# COUNTY SANITATION DISTRICTS OF LOS ANGELES COUNTY

July 10, 2017  
File No. 31-370.40.4A

**Comments on the Proposed 2016 Los Angeles Region  
Clean Water Act Section 303(d) List of Impaired Waters**

Figure 1. CSCI Reference Density Cloud (Santa Clara River Sites within Black Circle).

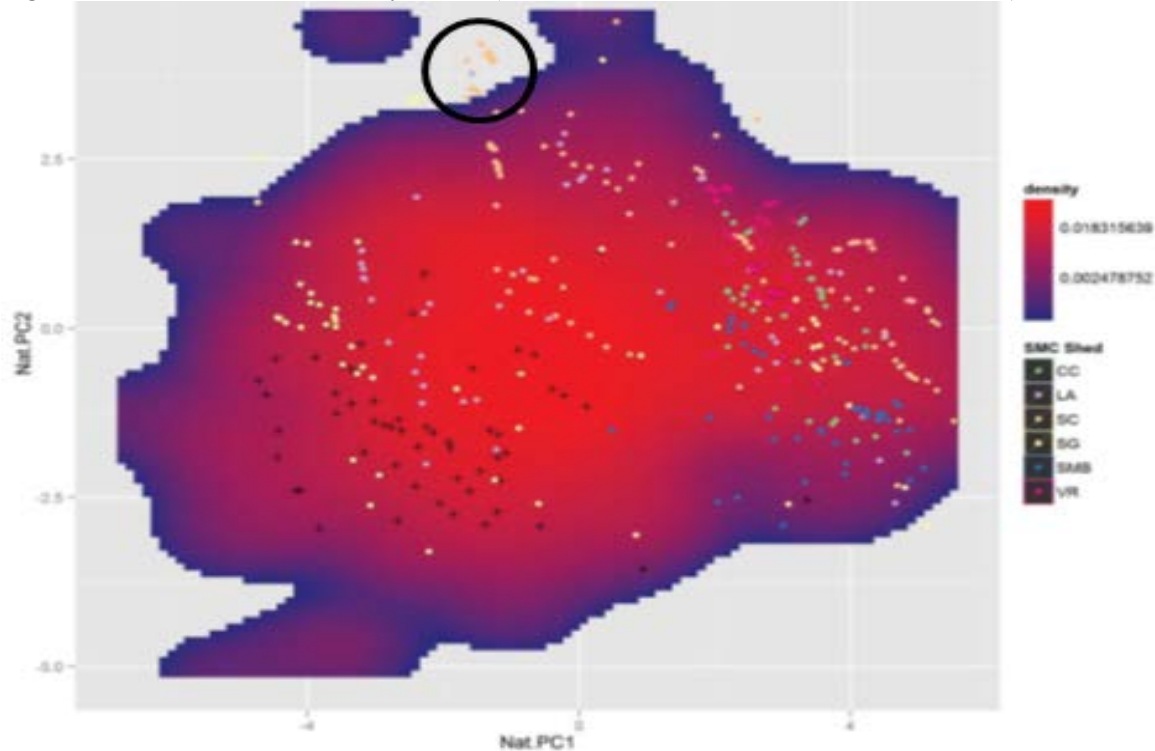
In response to written comments, the Regional Board stated, “The text accompanying the Reference Density Cloud in the presentation states, “*Could be used to establish exceptions for truly unique environmental settings.*” Nonetheless, it does not appear that any “truly unique environmental settings” have been established or are recognized by the State Bioassessment workgroup or other authority.” The Sanitation Districts acknowledge that there has been no formal designation of “truly unique environmental settings”. However, analyses suggest that a pronounced lack of reference sites in large watershed, low gradient, and low elevation systems still limits the identification of appropriate thresholds using the CSCI and casts a high degree of uncertainty on using the proposed 0.79 threshold.

Figure 1. CSCI Reference Density Cloud (Santa Clara River Sites within Black Circle).

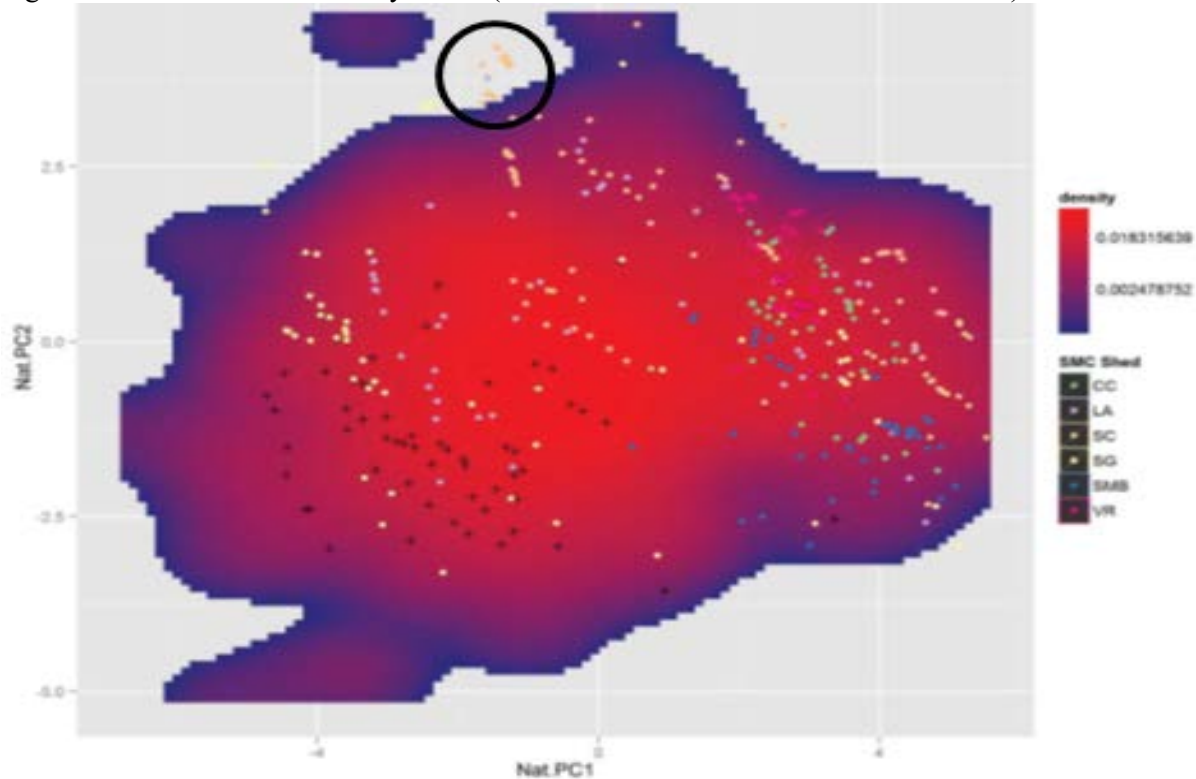
In response to written comments, the Regional Board stated, “The text accompanying the Reference Density Cloud in the presentation states, “*Could be used to establish exceptions for truly unique environmental settings.*” Nonetheless, it does not appear that any “truly unique environmental settings” have been established or are recognized by the State Bioassessment workgroup or other authority.” The Sanitation Districts acknowledge that there has been no formal designation of “truly unique environmental settings”. However, analyses suggest that a pronounced lack of reference sites in large watershed, low gradient, and low elevation systems still limits the identification of appropriate thresholds using the CSCI and casts a high degree of uncertainty on using the proposed 0.79 threshold.

Figure 2. Santa Clara River Reach 6, Classified as “Likely Constrained”

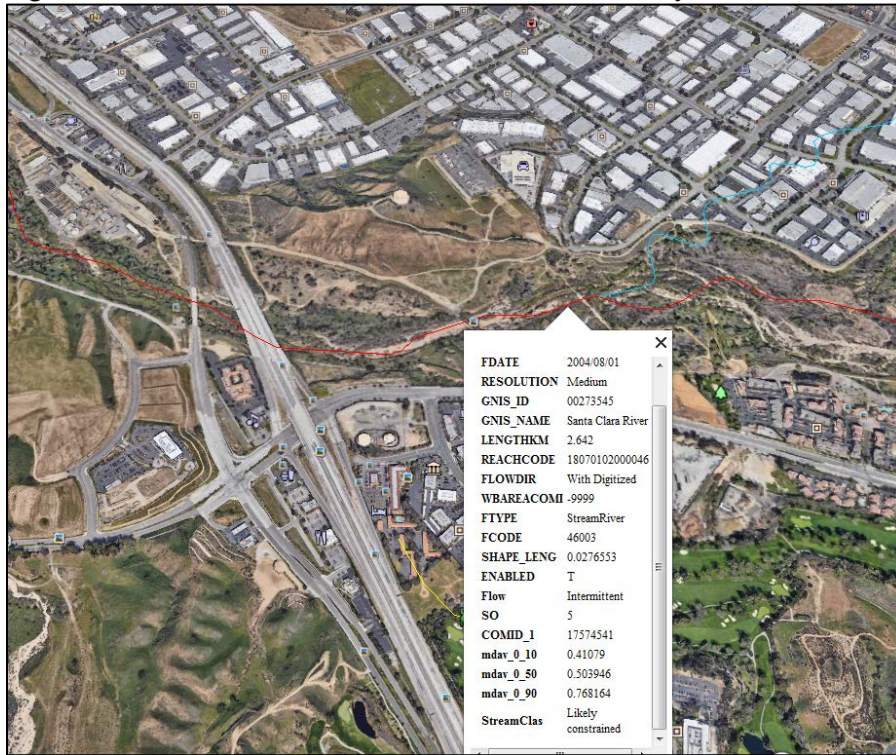
While there is no simple physical habitat that can be used for this evaluation, multiple other approaches are available. For example, the San Diego Regional Board’s (Region 9) most recent Integrated Report evaluated instream physical habitat data, CRAM data, and aerial imagery to evaluate habitat modification/hydromodification. A more recent tool developed by Southern California Coastal Water Research Project (SCCWRP) staff through a State Board effort has resulted in a quantitative tool to identify streams/reaches that are likely to be “constrained” by habitat or other, non-water quality parameters (the model used land cover, road density, canal density, mines, dams, aerial deposition, and non-native vegetation). When applying this tool to the Santa Clara Reach 6 location, SCCWRP determined that this location is “likely constrained”, meaning unlikely to achieve a CSCI score of 0.79 due to landscape development (Figure 2).

Figure 1. Pomona/San Jose Creek Receiving Water Map

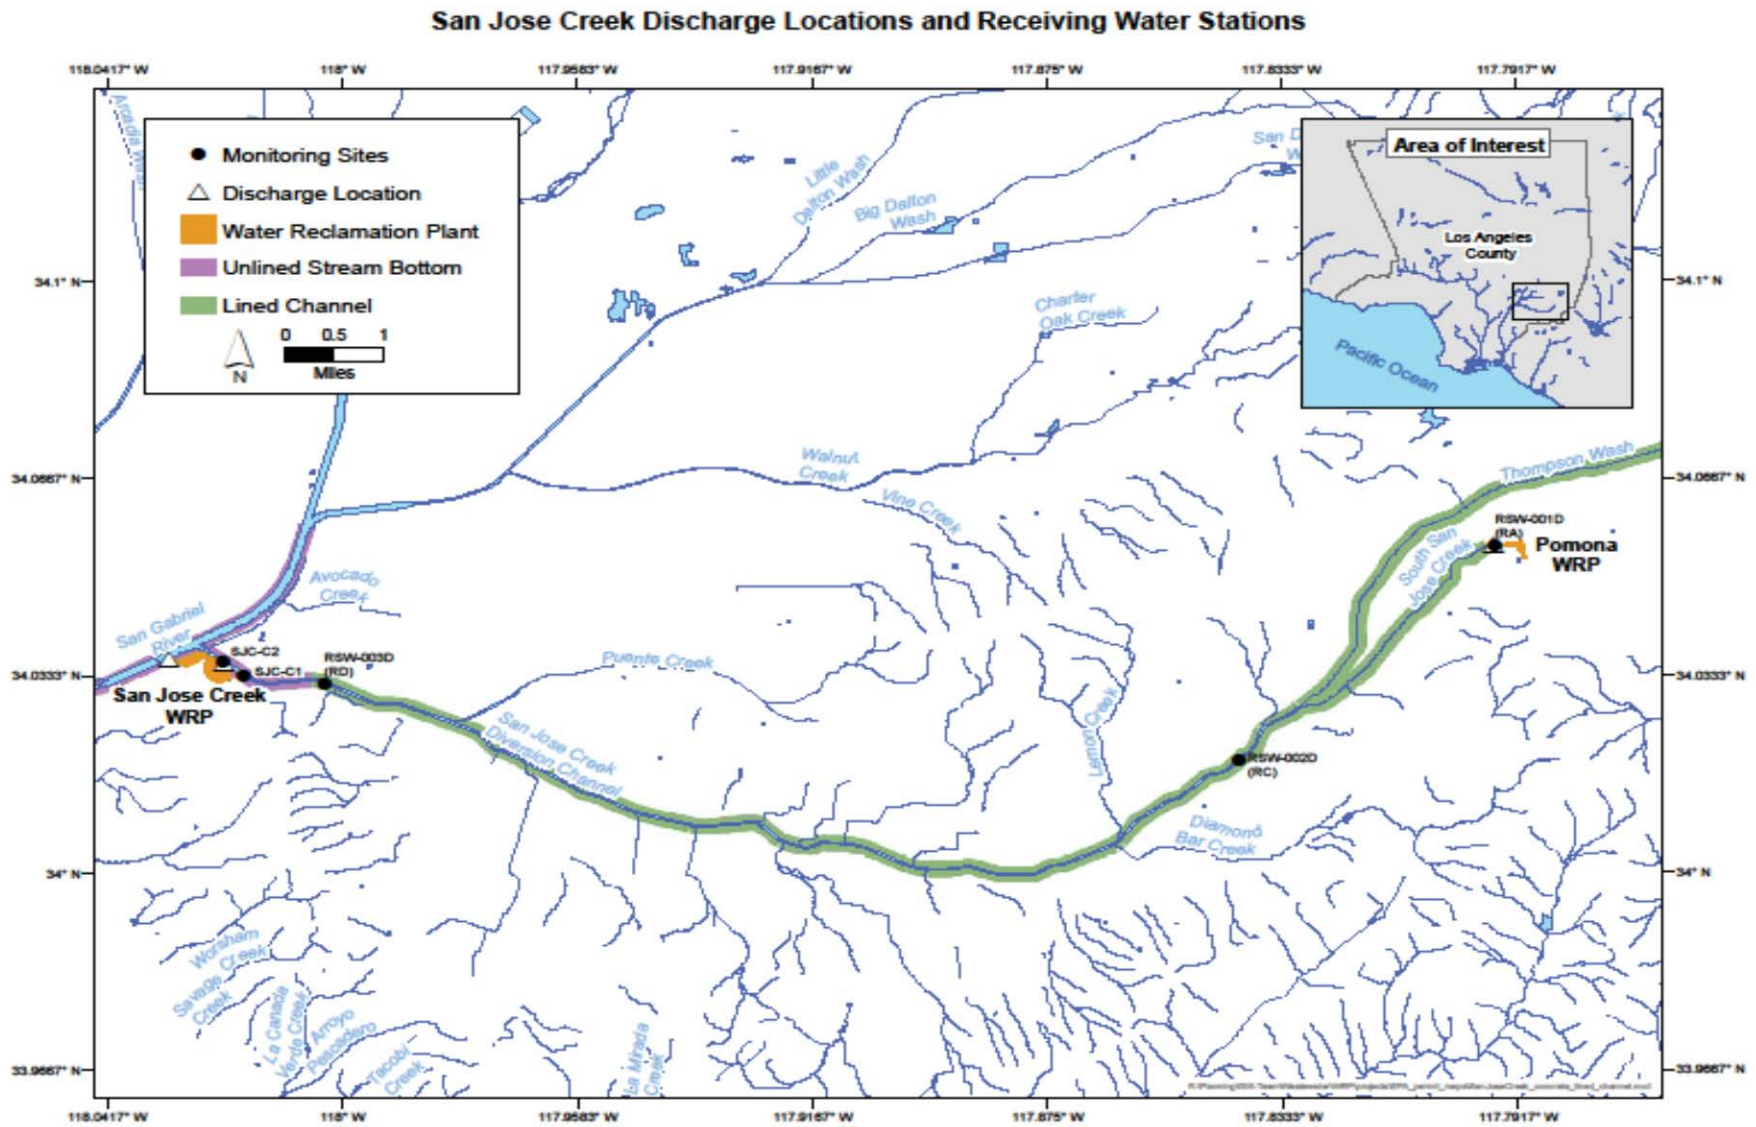
Tertiary treated water from the Pomona Water Reclamation Plant is discharged to the south fork of San Jose Creek and flows into Reach 1. Receiving water stations Pom-RC, Pom-RD, and SJC-C1 are located approximately 3, 12, and 12.5 miles from the upstream border of Reach 1, respectively. Reach 1 is fully lined in concrete from the upstream border to just upstream of SJC-C1 (Figure 1).

Figure 3. Measured Flow at Pom-RC and Pom-RD in the Absence of Discharge from Pomona WRP

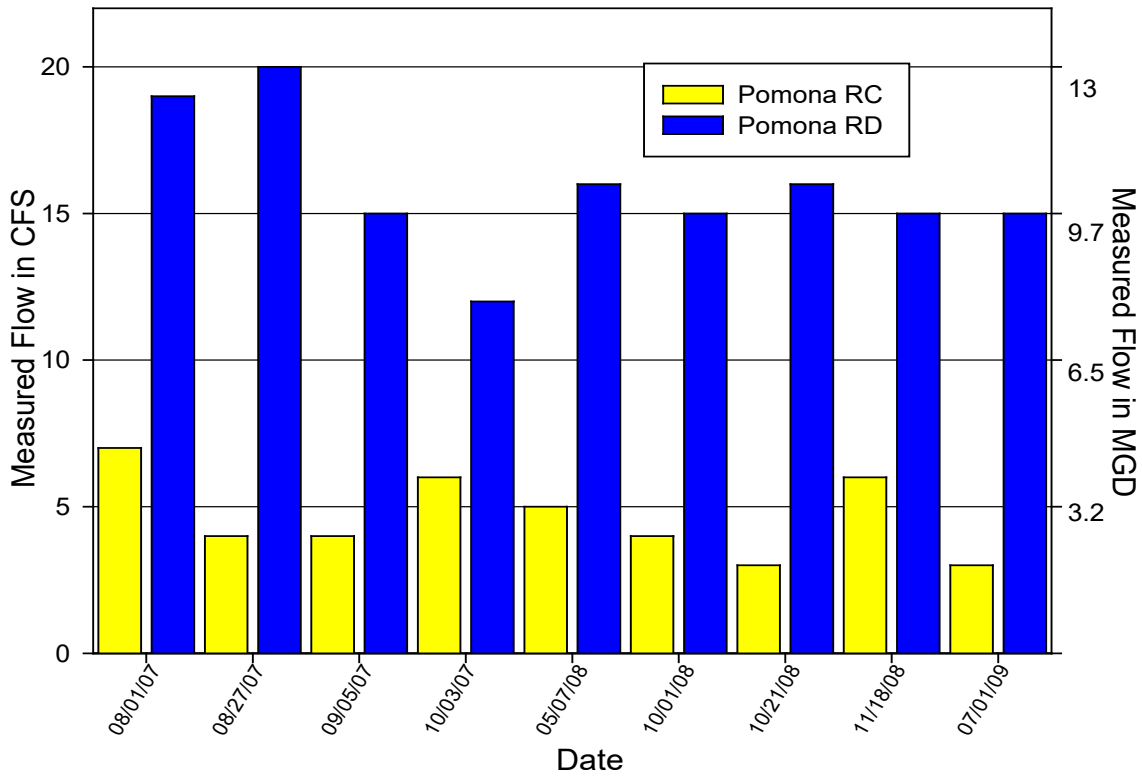
As observed by Sanitation Districts staff and corroborated by EPA staff<sup>1</sup>, groundwater exudes from relief structures distributed throughout the concrete-lined bottom, even in mid-summer (August) after several years of drought (Figure 2). In the absence of discharge from the Pomona Water Reclamation Plant or other observed discharges, flows in SJC between Pom-RC and Pom-RD increase by 200% to greater than 400% (Figure 3) due to the release of this groundwater, which has a localized average temperature of approximately 67 °F.<sup>2</sup> As this groundwater-dominated flow travels downstream, the temperature naturally rises (Figure 4) due to heat conduction through the warm concrete lining and solar radiation exposure in the unshaded channel (Figure 5 shows ambient air temperature as a proxy for solar radiation<sup>3</sup>). When the concrete channel ends upstream of SJC-C1, the water leaves the heat source (concrete channel) and mixes with additional groundwater, resulting in consistently cooler temperatures. The observed spatial and temporal temperature profile, coupled with no identifiable waste discharges and substantial groundwater contributions, clearly demonstrates that the temperature excursions in Reach 1 of San Jose Creek are not a result of waste discharges.

Figure 3. San Gabriel Reach 2 – Site R12

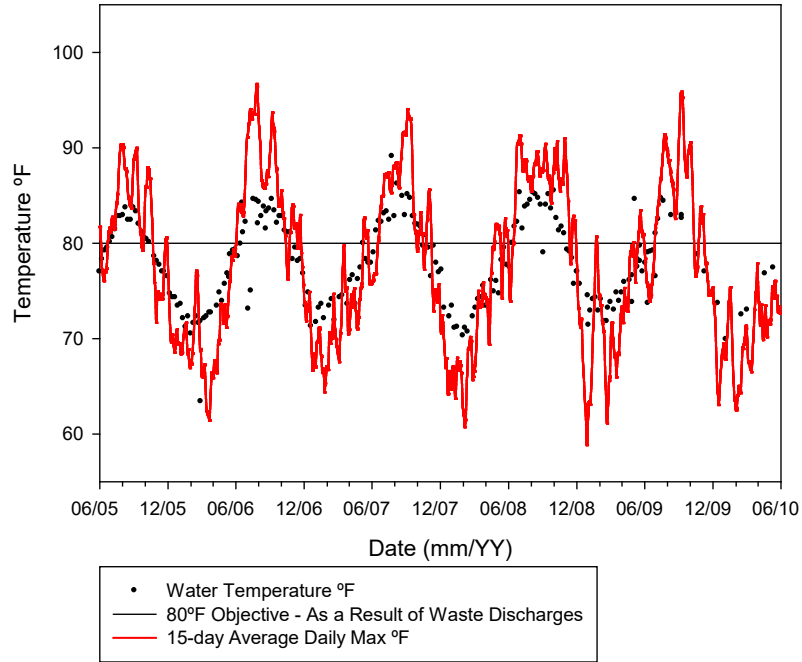
Tertiary treated water from the San Jose Creek Water Reclamation Plant (WRP) is discharged to the main stem of the San Gabriel River. The lower ¼ mile of Reach 2 is a fully lined concrete channel, containing the R2 receiving water station. Data from this station represent 215 of 232 data points. As explained in Fact Sheet #4, elevated temperatures in Reach 1 of San Jose Creek occurred even in the absence of observable waste discharges and were caused by conductive heating through the concrete lining and solar radiation exposure (Figure 4)<sup>2</sup>. Although a comprehensive assessment of flows, in the absence of WRP discharge, cannot be conducted along the San Gabriel River, the same conditions associated with the radiative and conductive heating exist in this part of San Gabriel River Reach 2. This is further supported by the fact that 99% of excursions above 80 °F in the receiving water environment occurred during the warmer months, June through October. The weight of evidence supports the contention that receiving water temperatures above 80 °F were a result of ambient and environmental conditions (i.e., summer weather and a concrete channel) and not waste discharges.
